DESCRIPTIVE REPORT TO ACCOMPANY
HYDROGRAPHIC SURVEY NO. H-8303 (PF-4256)
NORTH SIDE OF ALASKA PENINSULA AND
UNIMAK ISLAND, ALASKA

REVIEW OF HYDROGRAPHIC SURVEY

REGISTRY NO. H-8303

Alaska - North Side of Alaska Peninsula
North of Bechevin Bay

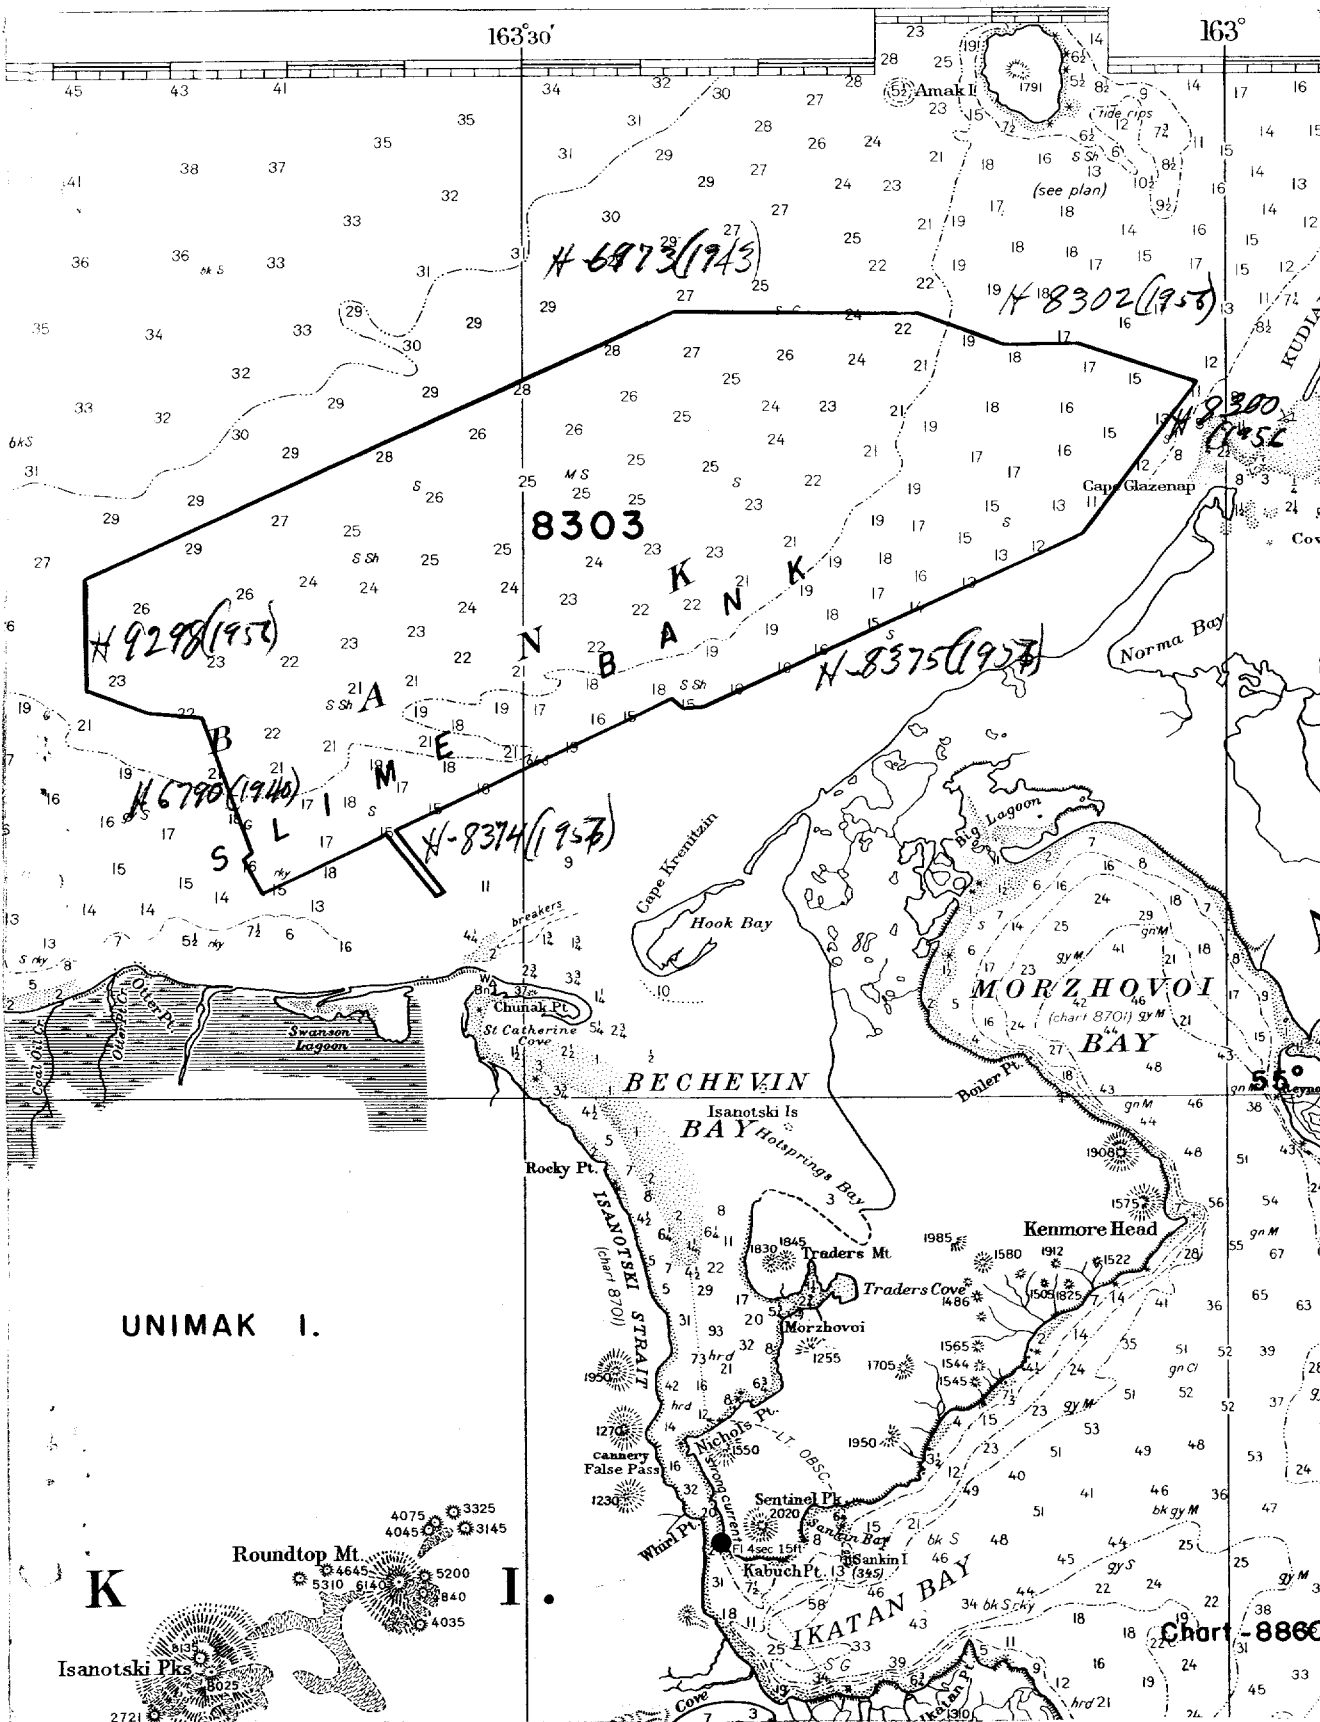
The junctions with contemporary surveys H-8298 (1956) on the west; H-8299 (1956) and H-8300 (1956) on the southeast;

and H-8302 (1956) on the northeast are adequate. In accordance with the Project Instructions junctions were made with prior surveys H-6790 (1940-41) and H-6973 (1943). Generally in depths over 20 fathoms the present survey is from 1/2 to 1 fathom shoaler in the overlapping areas. The differences in depths in part are due to the fact that no velocity corrections were applied to the present (1956) survey whereas they were applied to the 1940 to 1943 surveys on which the soundings are in true depths. For cartographic purposes, in the areas of disagreement, butt junctions were made with the prior surveys. The junctions with contemporary surveys H-8374 (1957) and H-8375 (1957) on the south will be considered in the reviews of those surveys.
